COVER SHEET  
CIVIL PLANS

240 15TH STREET SE  
PUYALLUP, WA 98372

**FORTRESS - PUYALLUP**

# CONSTRUCTION DETAILS

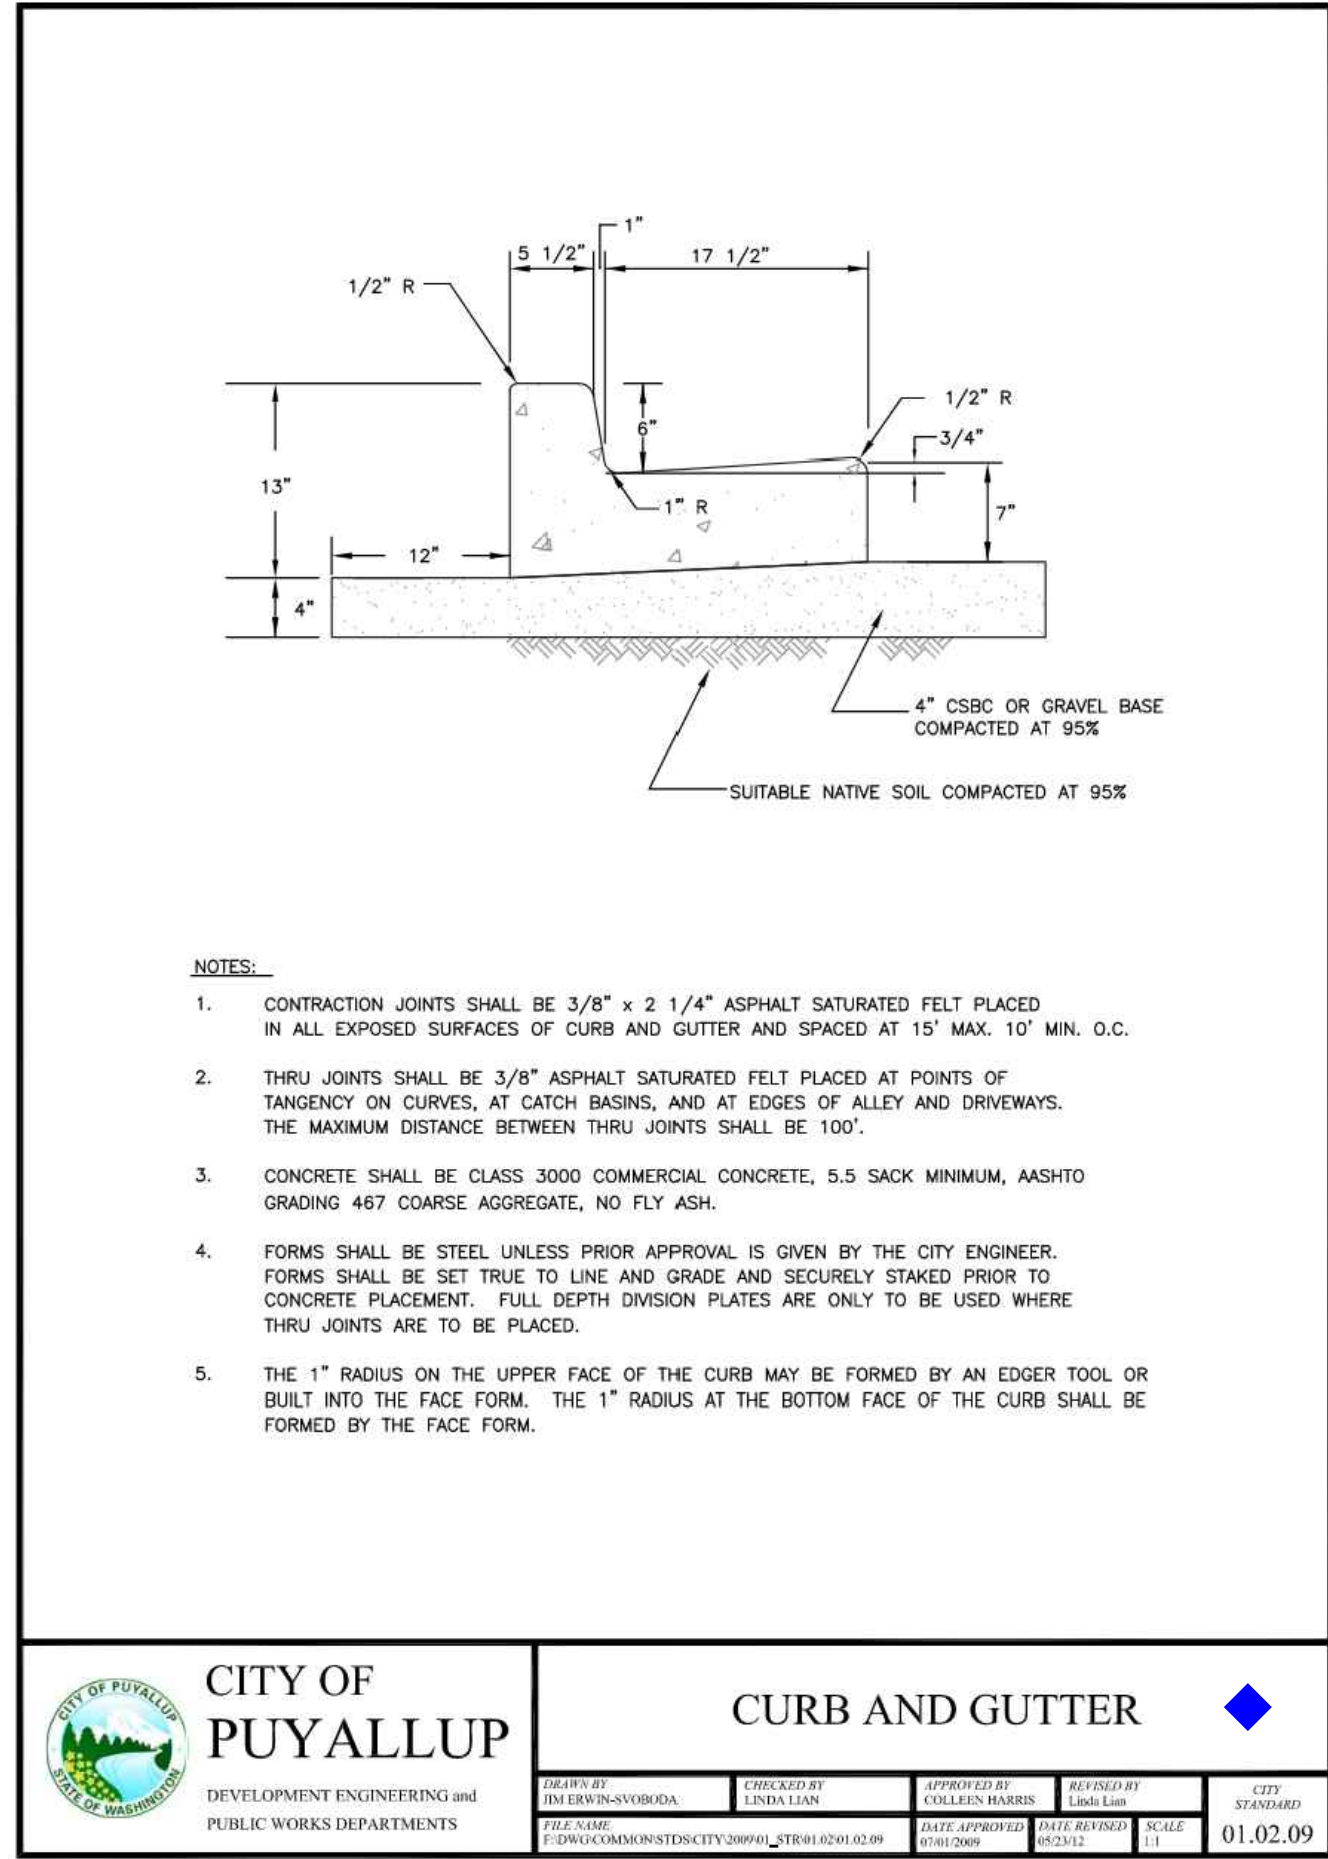
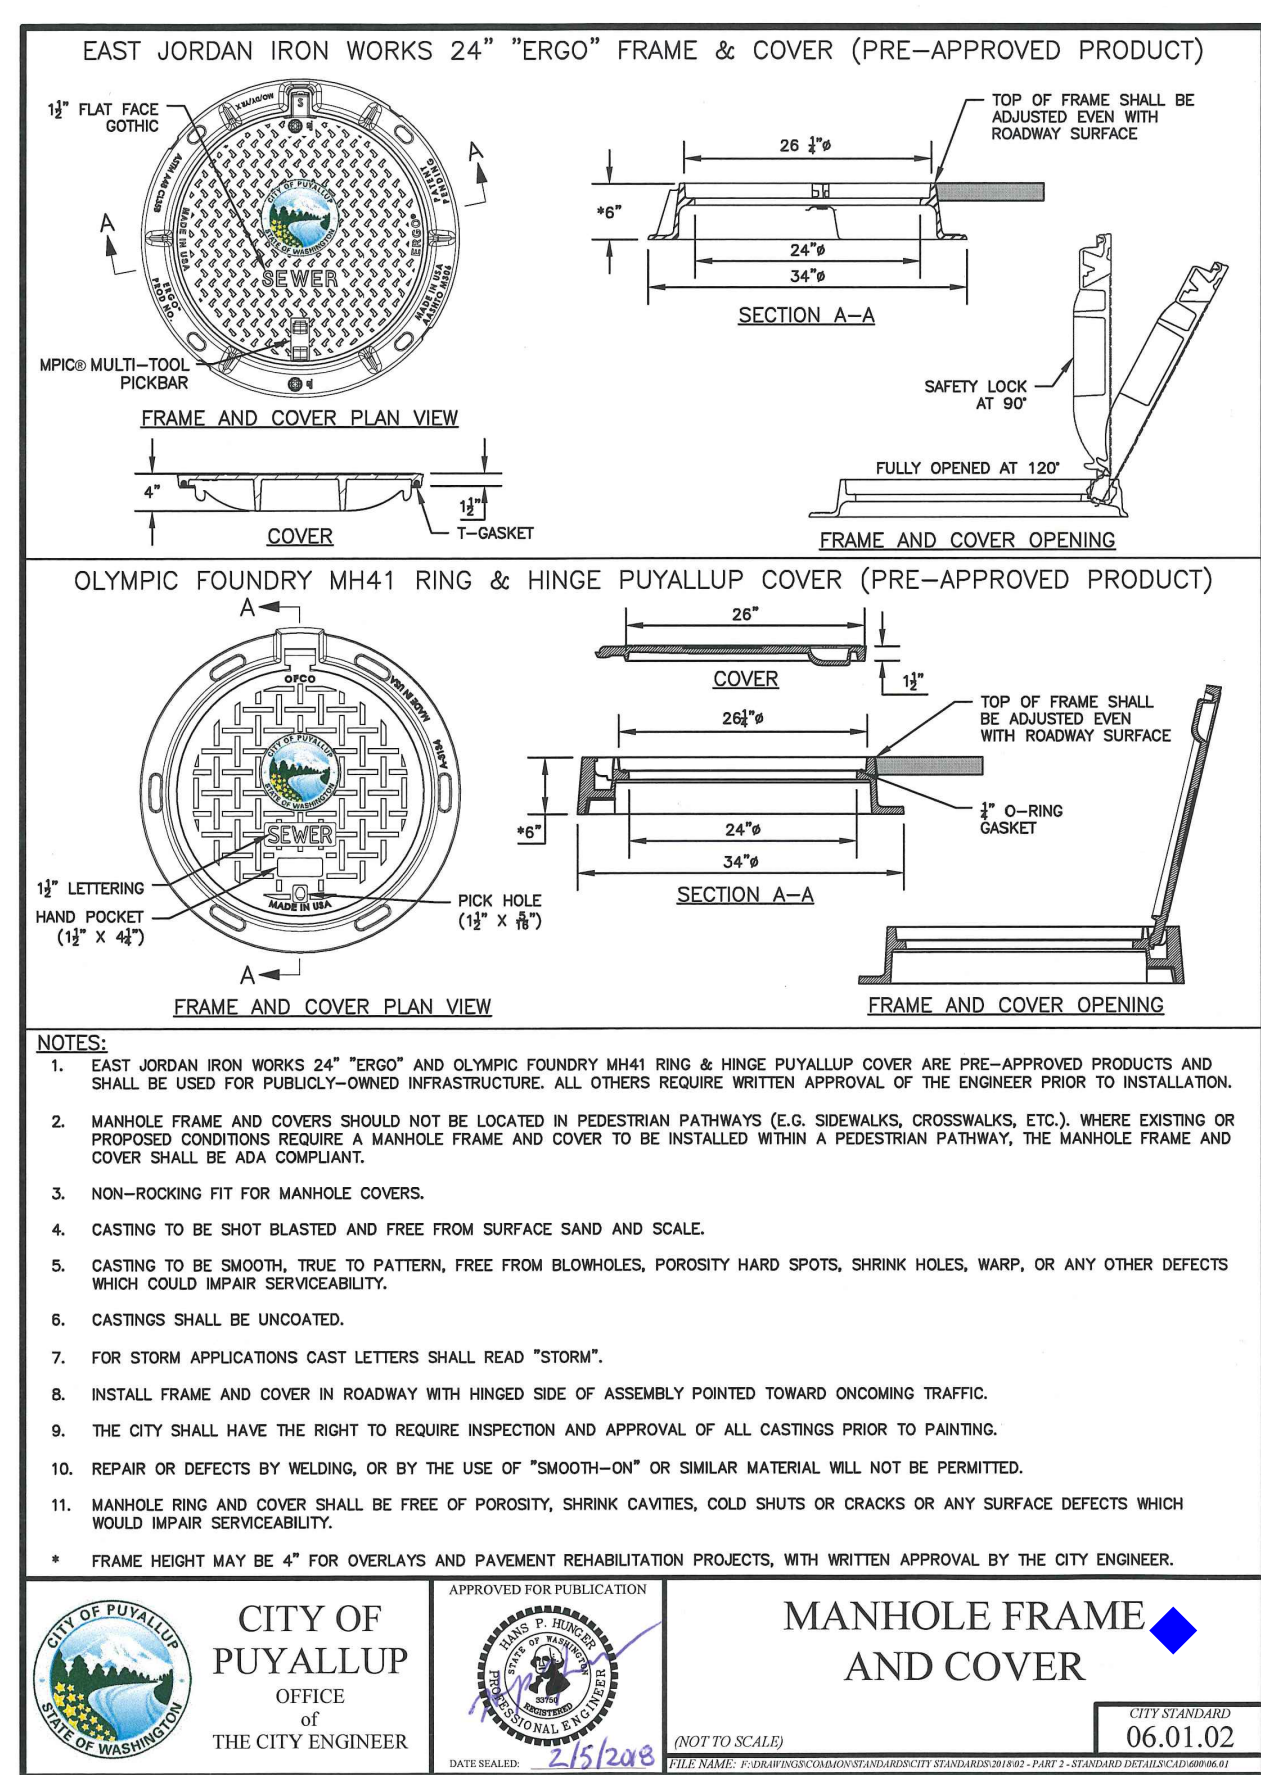
Civil Sheet C22: This water standard detail should be moved with the other water details on Sheet C24.
